DEVELOPMENT APPLICATION ASSESSMENT REPORT

Application Number:	DA2024/0193	
Responsible Officer:	Simon Ferguson Tuor	
Land to be developed (Address):	Lot 75 DP 12578, 40 Riverview Parade NORTH MANLY NSW 2100	
Proposed Development:	Construction of a dwelling house including swimming pool	
Zoning:	Warringah LEP2011 - Land zoned R2 Low Density Residential	
Development Permissible:	Yes	
Existing Use Rights:	No	
Consent Authority:	Northern Beaches Council	
Land and Environment Court Action:	No No	
Owner:	David Christopher William Dowell	
Applicant:	David Christopher William Dowell	
Application Lodged:	04/03/2024	
Integrated Development:	No	
Designated Development:	No	
State Reporting Category:	Residential - Single new detached dwelling	
Notified:	08/03/2024 to 22/03/2024	
Advertised:	Not Advertised	
Submissions Received:	0	
Clause 4.6 Variation:	Nil	
Recommendation:	Approval

Figure 1. North Elevation (red highlighting building envelope numerical non-compliance)

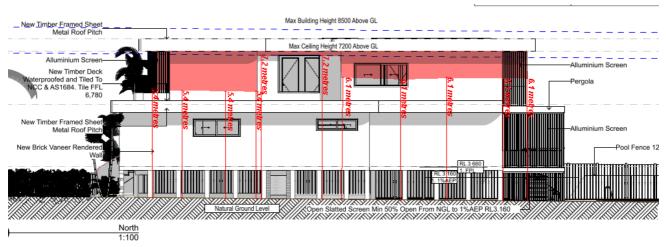
The proposal sits outside of the building envelope on the North Elevation as depicted in Figure 1, and the South Elevation as depicted Figure 2. It is noted that the breach in building envelope is largely resultant of the required Flood Planning Level of 3.66 AHD as the site is located in High Flood Risk precinct. Despite this, the proposal complies with the statutory height standard.

As noted above, the envelope non-compliance is exacerbated by the raised floor level of the site. The height and bulk is consistent with the established character of the wider area and anticipated by the low density zoning. The proposal also complies with the side setback and landscaping controls to ensure a compatible visual presentation. It is considered that the proposal presents an overall appropriate height, and scale given the Flood Planning Level

A detailed assessment has been undertaken that concludes the proposal is consistent with the objectives of the control as outlined below. Therefore, the variation to the side boundary envelope is supportable in this circumstance.
